RICHLAND COUNTY  
PLANNING COMMISSION

OCTOBER 6, 2008

**Agenda**

To: Planning Commission  
From: Anna Almeida, Deputy Planning Director  
CC: Joseph Kocy, Planning Director  
Date: 9/26/2008  
Re: Roper Pond Appeal

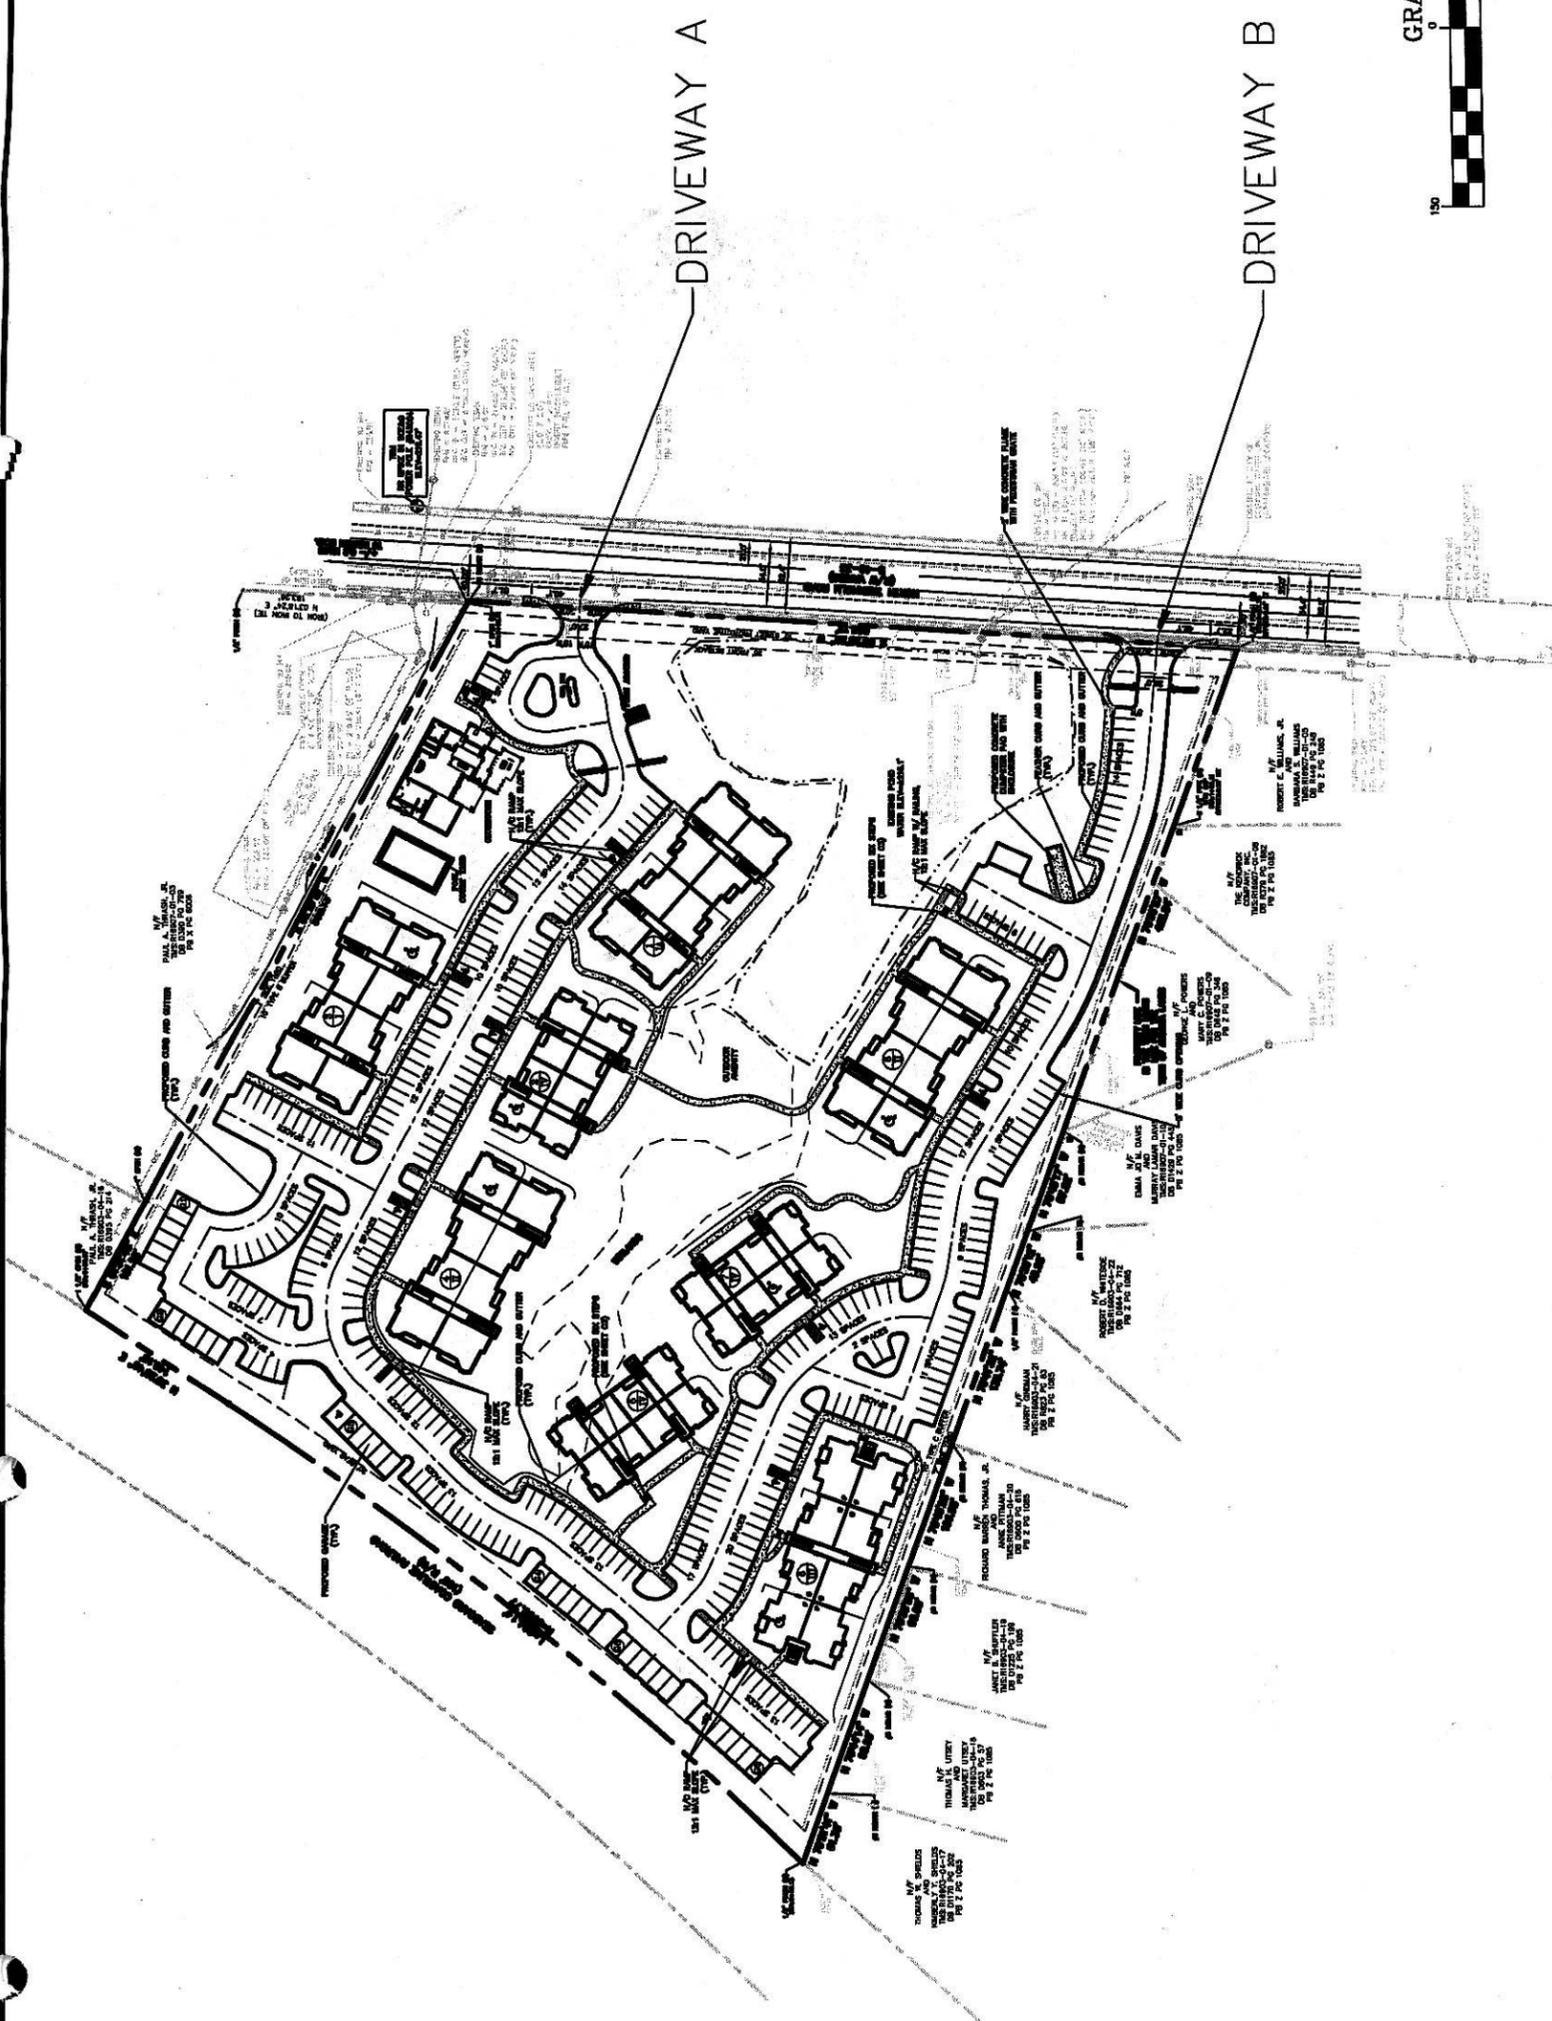
1. Submission of revised plans identifying the following:
  - Label existing sidewalks on Trenholm Road; provide existing width and connection to internal sidewalk.

- Lighting plan not in compliance with Sec. 26.-177, consideration for the location of on site lighting regarding spillage onto adjacent residential property.

- Preservation of grand trees is a requirement, if one must be removed mitigation is 3:1 ratio. Additional detail on mitigated trees and required landscaping added to plans. Mitigated trees shall have a different symbol on the plans. Preservation of trees in the green area next to the pond.

- Phasing plan must be provided.
  - Copy of tree survey with a site plan overlay.
  - The retaining wall needs additional details and location on site.

- Plans must include the club house and pool if approval is being sought.

2. Approval from the Fire Marshall; concerns on access to the back of buildings and control access gates must be addressed.
3. Copy of the Wetlands letter submitted to the Army Corp of Engineers for the Flood Coordinator and the elevation of the pond noted on the plans for Flood approval

4. SCDOT comments on the Traffic Study and the improvements identified. The mechanisms to trigger the re-evaluation of the project for traffic as part of the mitigation identified in the Traffic Management Plan. Provision of turn lanes internal to the site. The Traffic Management Plan requires updates to verify the dates the study was completed. The study dates should be prior to May 24, 2008 as this was the stated last day of school.

5. Plans and information on the pond improvements with a recommendation for sustainable grasses around the pond and how the pond will be protected from silt during construction. Water quality measures that are above minimum standards noted on a plan with recommendation for zero discharge of pollutants.

Two points of access to the development are proposed on Trenholm Road. An internal loop drive provides access to 204 multi-family apartment units and a 5,000 square foot clubhouse with pool. An existing pond is located in the center of the site. 357 total parking spaces are provided, with 36 of the spaces located in one of six garages at the rear of the site. Internal sidewalks are shown, but sidewalks are not shown along Trenholm Road.

**PC MEETING DATE:** September 8, 2008  
**RC PROJECT:** 08-26 MA  
**APPLICANT:** David Tuttle  
**PROPERTY OWNER:** Land Holdings Two, LLC  
**LOCATION:** Two Notch & Wildewood Park Drive

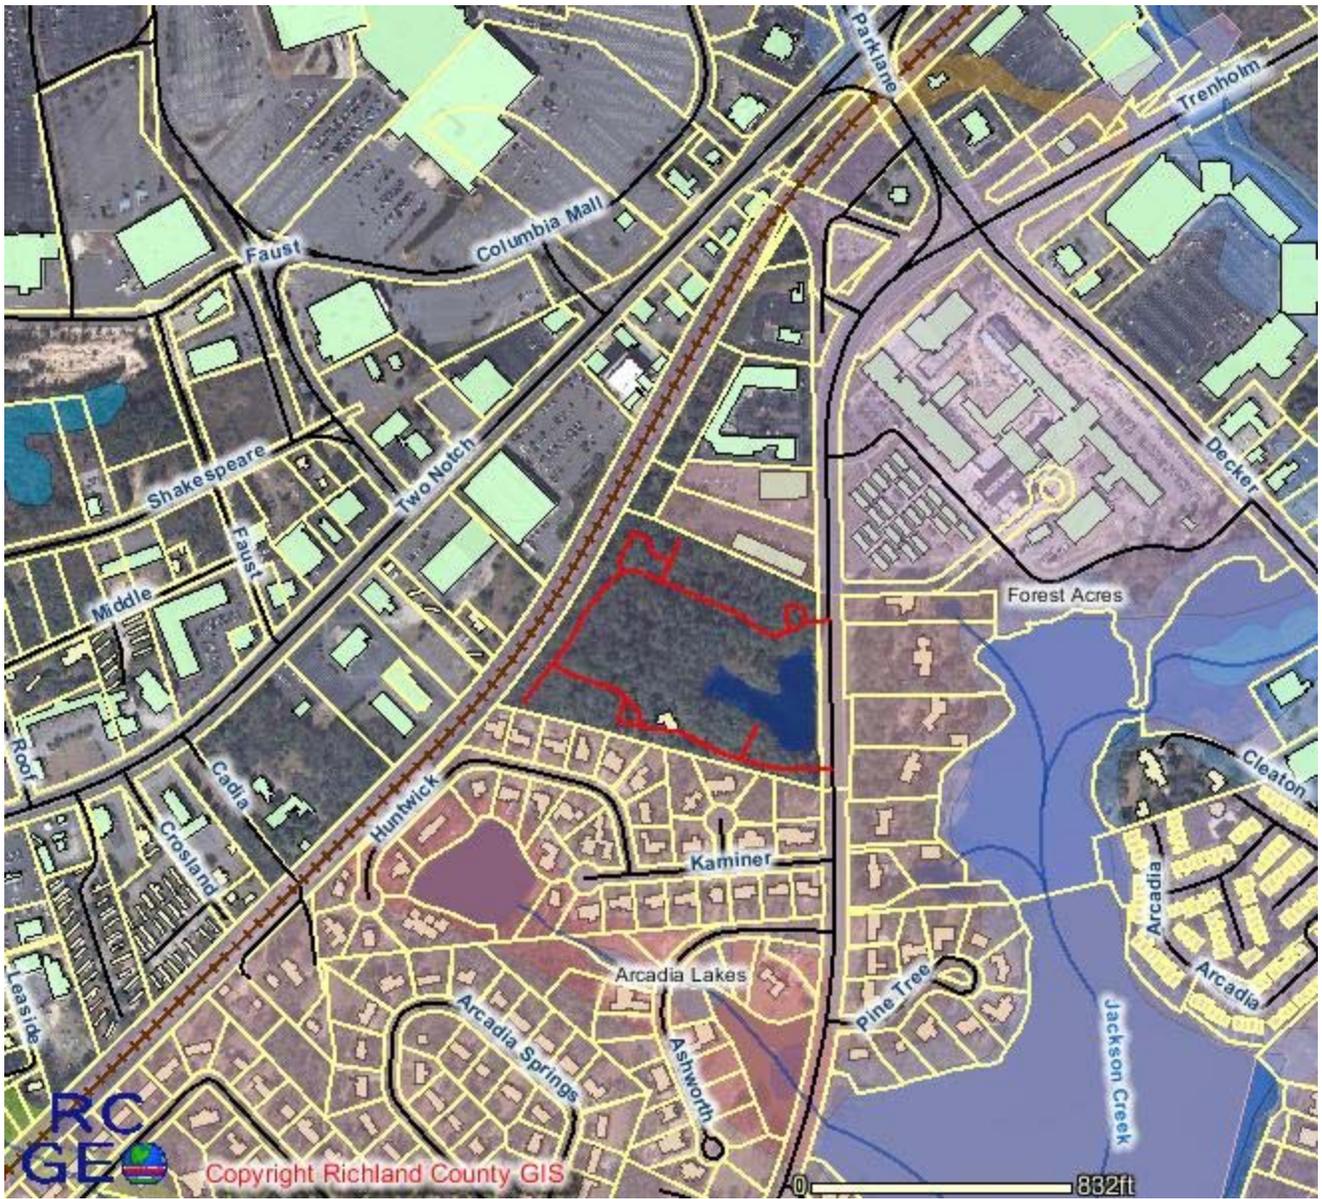
1. Submission of revised plans identifying the following:
  - Terminology on plans to be consistently labeled and remove parcels not part of Planned Development

- Single access to the development from Wildwood Park Road is major concern remove all other access noted on plans
  - List of permitted uses requires reduction in scope and limitations on square footage

- Name of project approval
  - Details of the Levy Fence around perimeter of development
  - Buffers noted on plans
  - Trails and connectivity to surrounding community unknown at this time and the Planned Development proposal does not contain this information which is required

- Parking calculations not in compliance with Section 26-173
  - Right of way widths not in compliance with regulations
2. Provision of information on Low Impact Development (LID) and the specifics for this development for the Preliminary Plans

3. Drainage concerns from Soil and Water with protection for Storm water runoff and sediment control, plans to be provided and should exceed minimum standards
